SAN JUAN RIVER BASIN
ADJUDICATION

La Plata River Section

**ORDER CORRECTING MISTAKES REGARDING MAP ERRORS IN TWENTY-ONE
CONSENT ORDERS IN THE LA PLATA ADJUDICATION**

Tract Number
SJLP-008-0076
 Jackson Ditch
 November 20, 2023

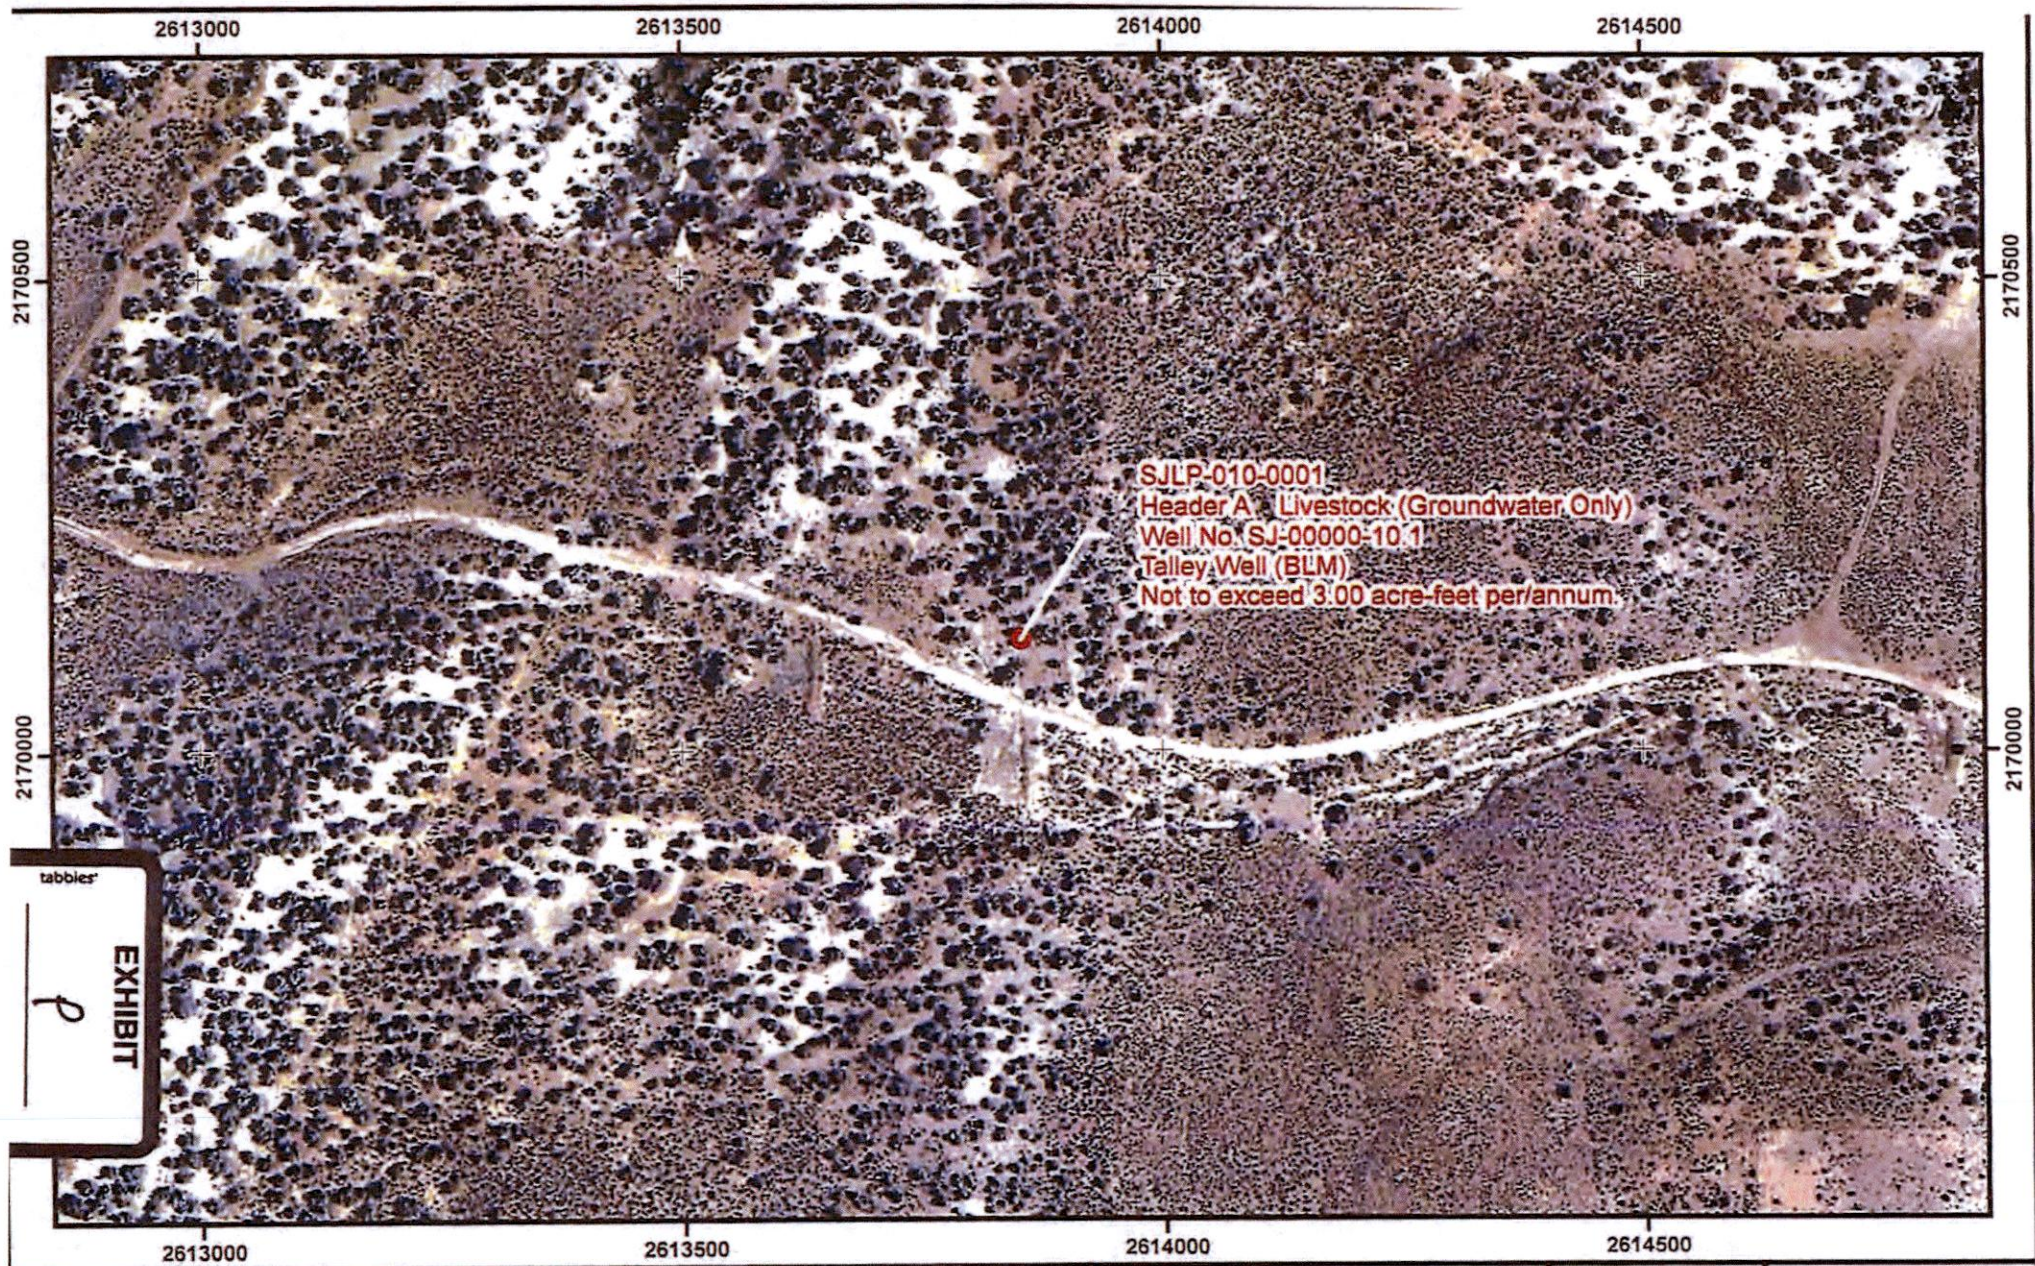
<p>Sharon Sprout Jess Sprout 3 County Road 1788 Farmington, NM 87401</p>	<p>008-0076</p>	<p>4/30/2014</p>	<p>AF-01-410</p>	<p>A, B</p>	<p>Heading B: No Right for 0.5 acre is labeled as Heading A for 0.5 acre on map. Map No Right Polygon A needs to be changed to Polygon B.</p>	<p>Corrected map attached as Exhibit O. Polygon A for 0.5 No Right acres is corrected to Polygon B for 0.5 No Right acres.</p>
<p>Bureau of Land Management US Department of Justice c/o David Gehlert 999 18th Street South Terrace Suite 370 Denver, CO 80202</p>	<p>010-0001 Map POD differs from SO POD.</p>	<p>8/11/2009</p>	<p>AF-01-541</p>	<p>A</p>	<p>Well number under Point of Diversion in Subfile Order, SJ-00000-10.1, is completely different number from long number stated on map. The map does not match the description in the Subfile Order.</p>	<p>Corrected map attached as Exhibit P. Corrected map states: SJLP-010-0001 Header A Livestock (Groundwater Only) Well No. SJ-00000-10.1 Talley Well (BLM) Not to exceed 3.00 acre feet per/annum.</p>

Subfile Number
SJLP-010-0002
 Harris Well
 November 28, 2023

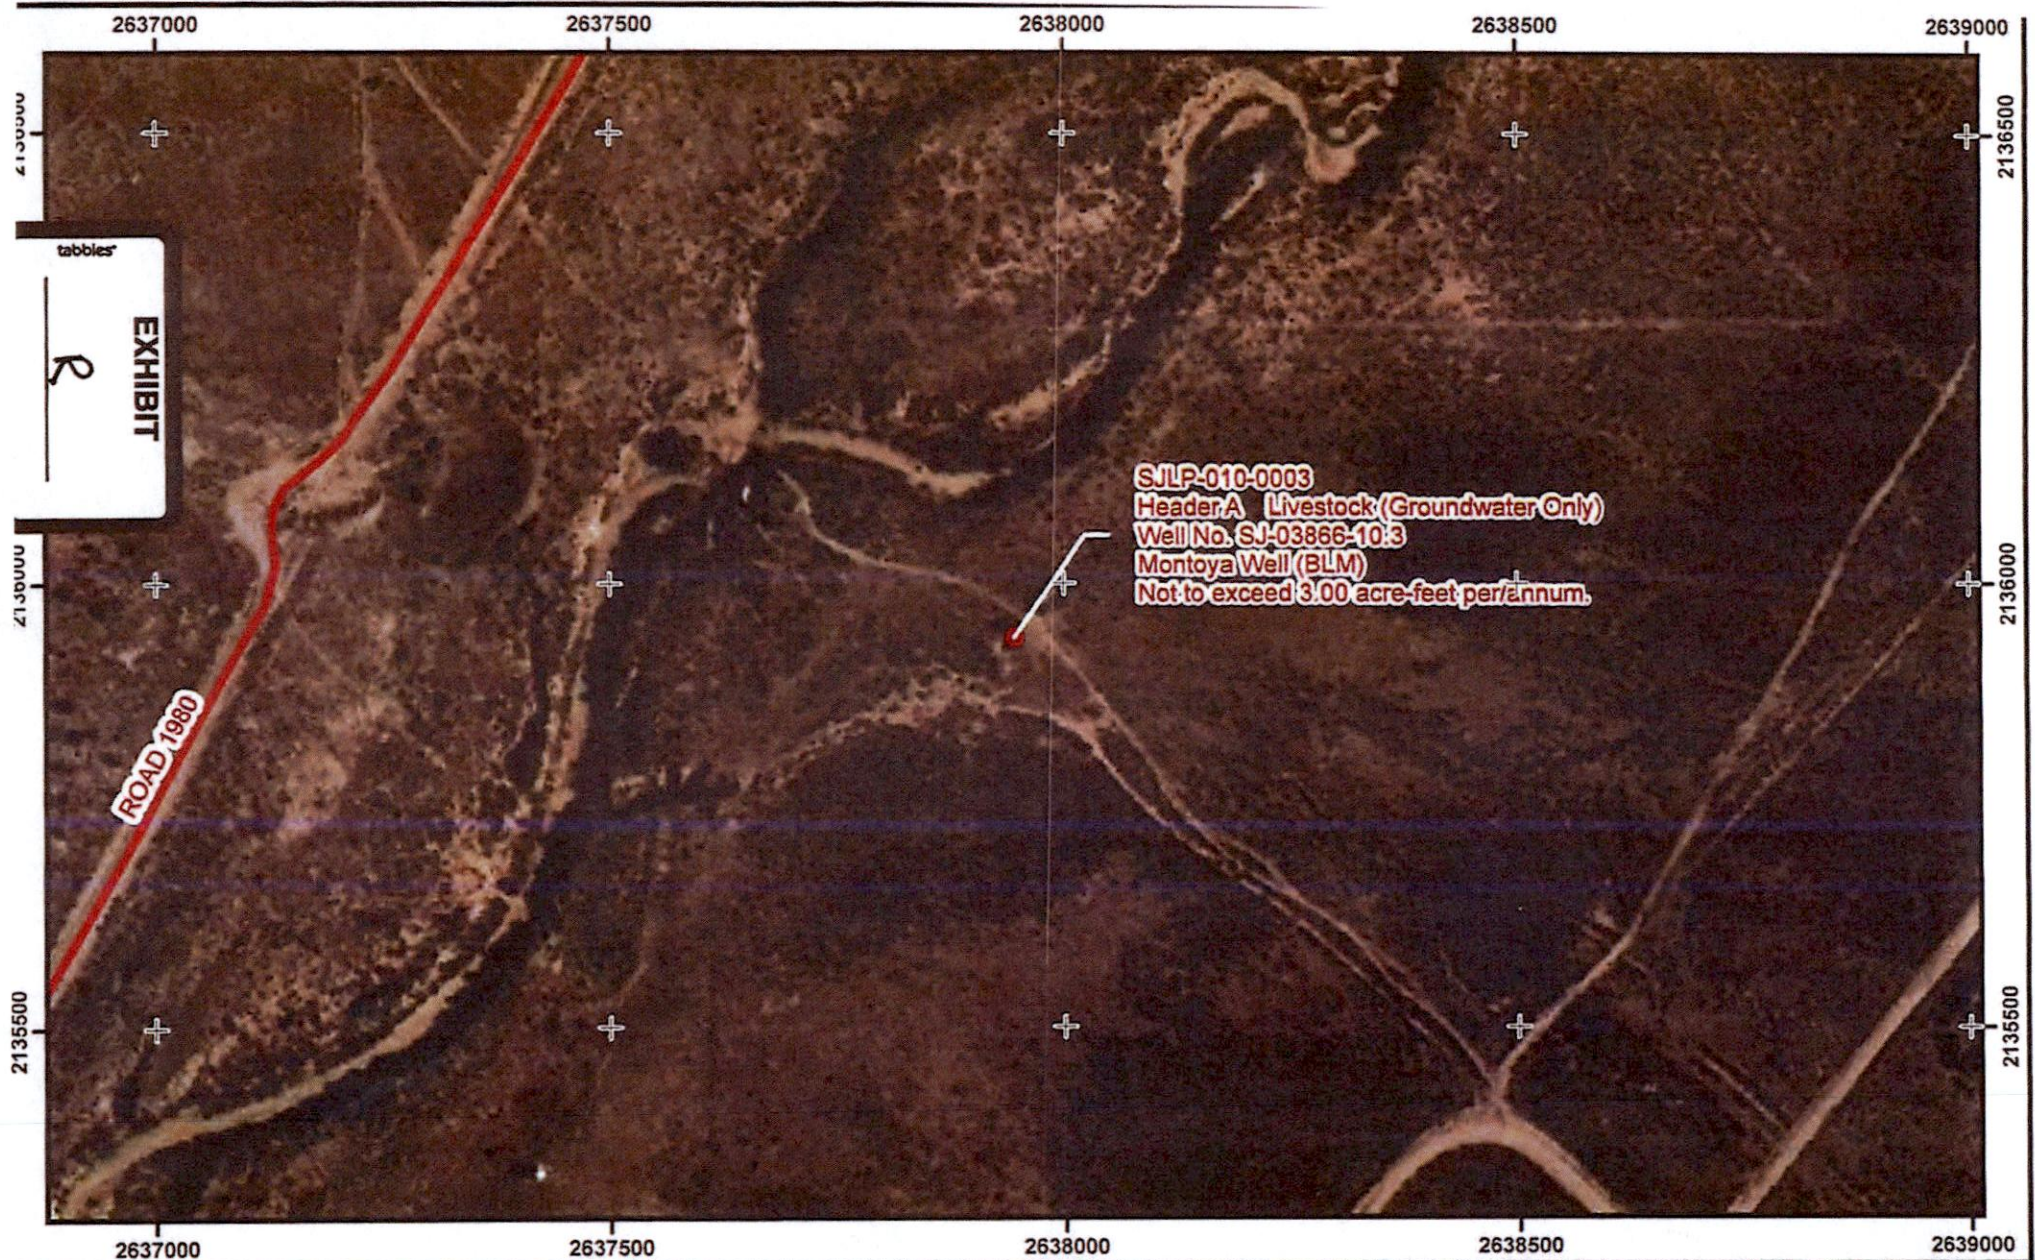
<p>Bureau of Land Management US Department of Justice c/o David Gehlert 999 18th Street South Terrace Suite 370 Denver, CO 80202</p>	<p>010-0002 Map POD differs from SO POD.</p>	<p>8/11/2009</p>	<p>AF-01-542</p>	<p>A</p>	<p>Well number under Point of Diversion in Subfile Order, SJ-03867-10.2, is completely different number from long number stated on map. The map does not match the description in the Subfile Order.</p>	<p>Corrected map attached as Exhibit Q. Corrected map states: SJLP-010-0002 Header A Livestock (Groundwater Only) Well No. SJ-03867-10.2 Harris Well (BLM) Not to exceed 3.00 acre feet per/annum.</p>
<p>Bureau of Land Management US Department of Justice c/o David Gehlert 999 18th Street South Terrace Suite 370 Denver, CO 80202</p>	<p>010-0003 Map POD differs from SO POD.</p>	<p>8/11/2009</p>	<p>AF-01-543</p>	<p>A</p>	<p>Well number under Point of Diversion in Subfile Order, SJ-03866-10.3, is completely different number from long number stated on map. The map does not match the description in the Subfile Order.</p>	<p>Corrected map attached as Exhibit R. Corrected map states: SJLP-010-0003 Header A Livestock (Groundwater Only) Well No. SJ-03866-10.3 Montoya Well (BLM) Not to exceed 3.00 acre feet per/annum.</p>

SJLP-010-0002
 Header A Livestock (Groundwater Only)
 Well No. SJ-03867-10.2
 Harris Well (BLM)
 Not to exceed 3.00 acre-feet per/annum.

Subfile Number
SJLP-011-0001
 Hartley Springs Well
 November 28, 2023

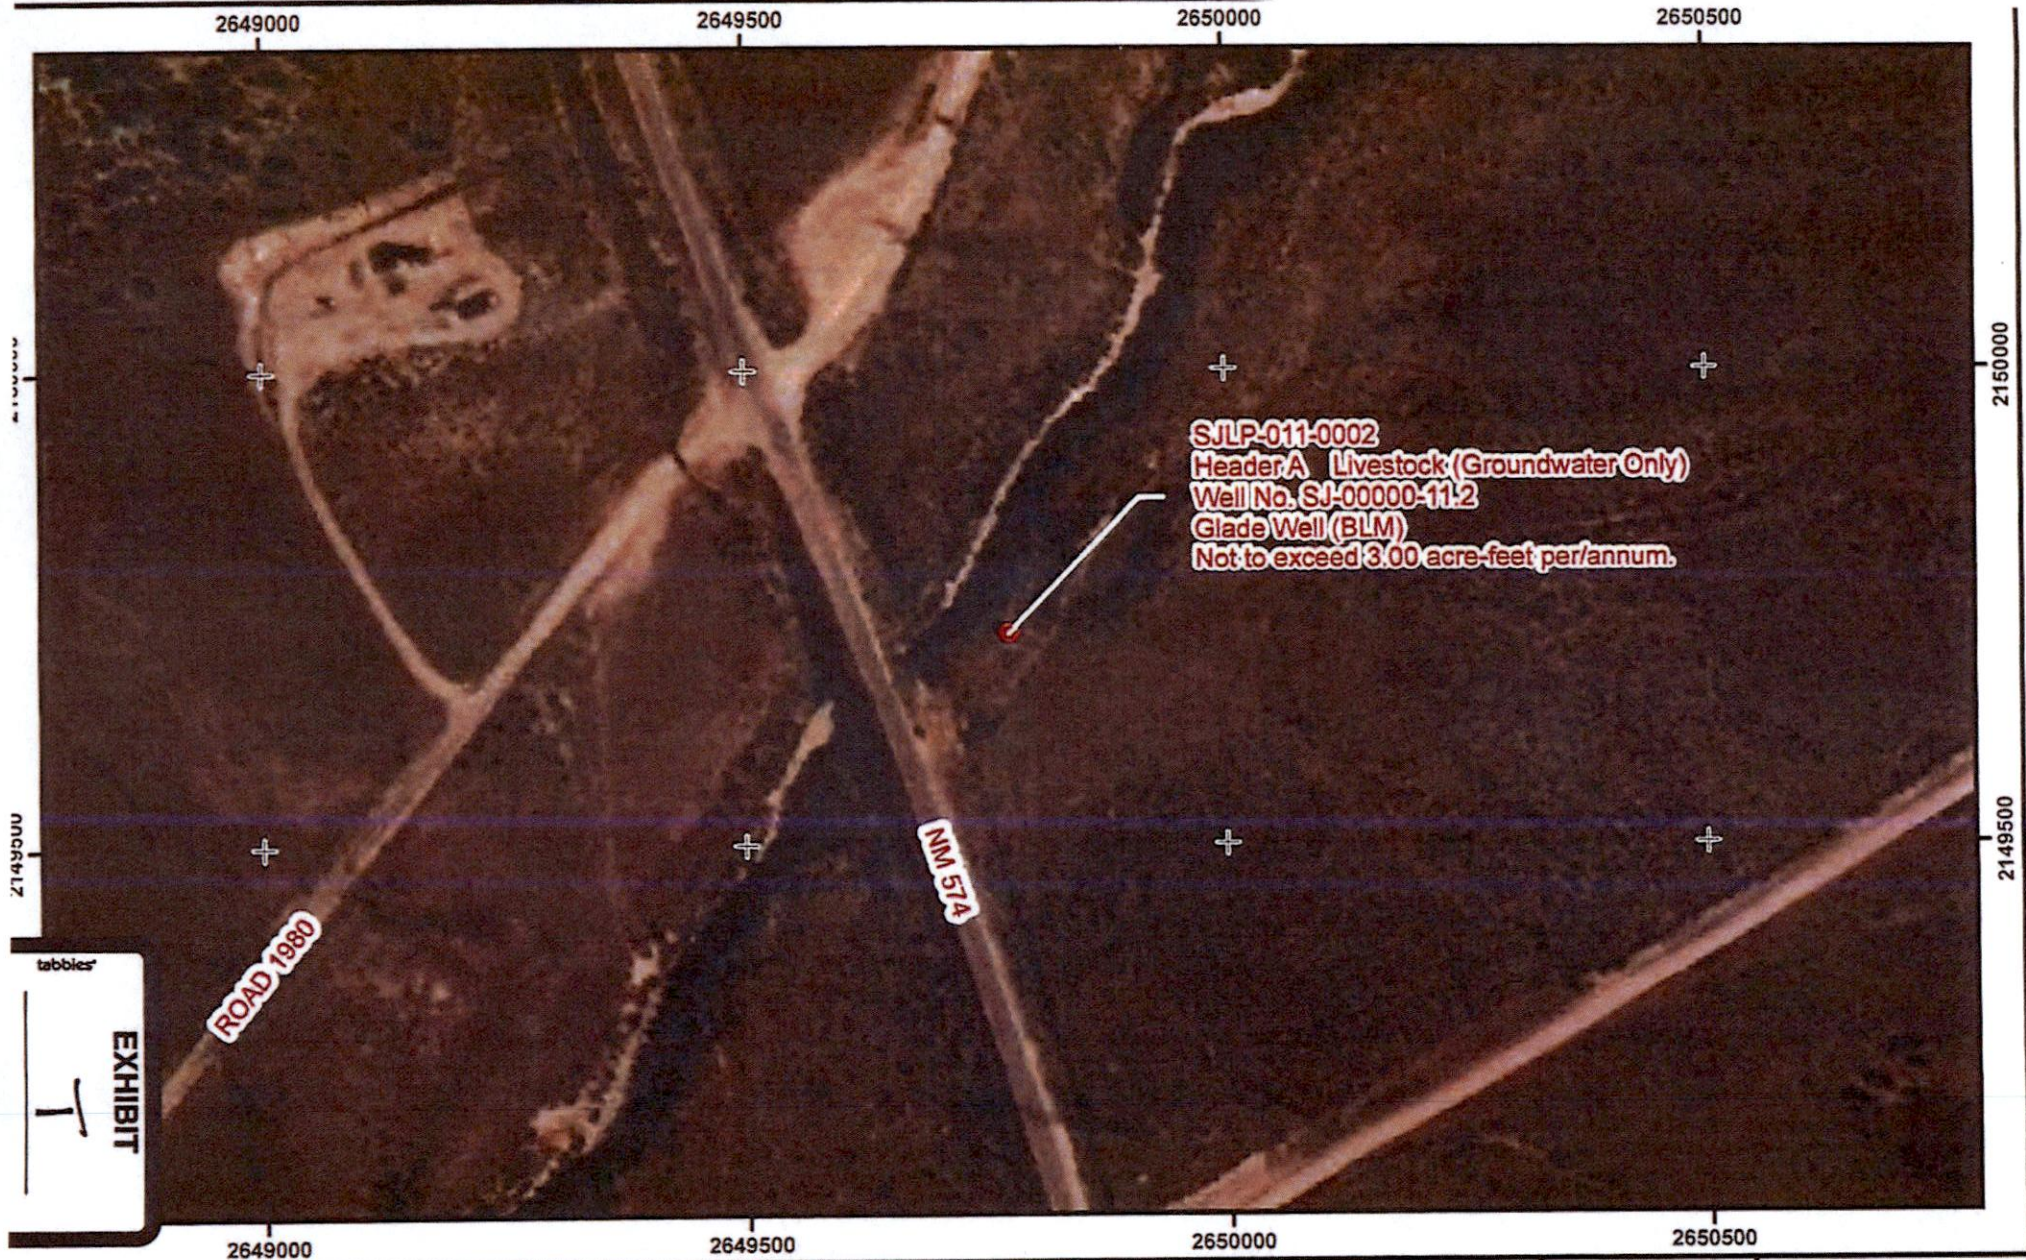
<p>Bureau of Land Management US Department of Justice c/o David Gehlert 999 18th Street South Terrace Suite 370 Denver, CO 80202</p>	<p>011-0001 Map POD differs from SO POD.</p>	<p>8/11/2009</p>	<p>AF-01-544</p>	<p>A</p>	<p>Well number under Point of Diversion in Subfile Order, SJ-03865-11.1, is completely different number from long number stated on map. The map does not match the description in the Subfile Order.</p>	<p>Corrected map attached as Exhibit S. Corrected map states: SJLP-011-0001 Header A Livestock (Groundwater Only) Well No. SJ-03865-11.1 Hartley Springs Well (BLM) Not to exceed 3.00 acre feet per/annum.</p>
<p>Bureau of Land Management US Department of Justice c/o David Gehlert 999 18th Street South Terrace Suite 370 Denver, CO 80202</p>	<p>011-0002 Map POD differs from SO POD.</p>	<p>8/11/2009</p>	<p>AF-01-545</p>	<p>A</p>	<p>Well number under Point of Diversion in Subfile Order, SJ-00000-11.2, is completely different number from long number stated on map. The map does not match the description in the Subfile Order.</p>	<p>Corrected map attached as Exhibit T. Corrected map states: SJLP-011-0002 Header A Livestock (Groundwater Only) Well No. SJ-00000-11.2 Glade Well (BLM) Not to exceed 3.00 acre feet per/annum.</p>

SJLP-011-0001
 Header A Livestock (Groundwater Only)
 Well No. SJ-03865-11.1
 Hartley Springs Well (BLM)
 Not to exceed 3.00 acre-feet per/annum.
